Product Change Notification (PCN)

PCN #: 6B-2021

DATE: 21st June 2021

5.2 Shipping Box Label

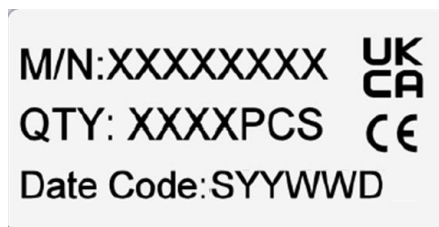
- Addition of UKCA logo to the right-hand side of the label
- This is applicable to all part numbers in this PCN.

5.3 Carton label

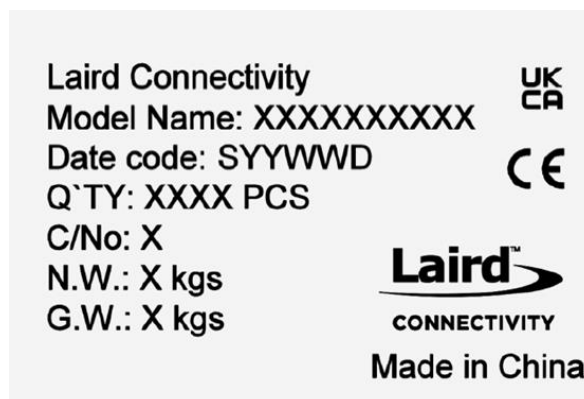
- Addition of UKCA logo to the right-hand side of the label
- This is applicable to all part numbers in this PCN.
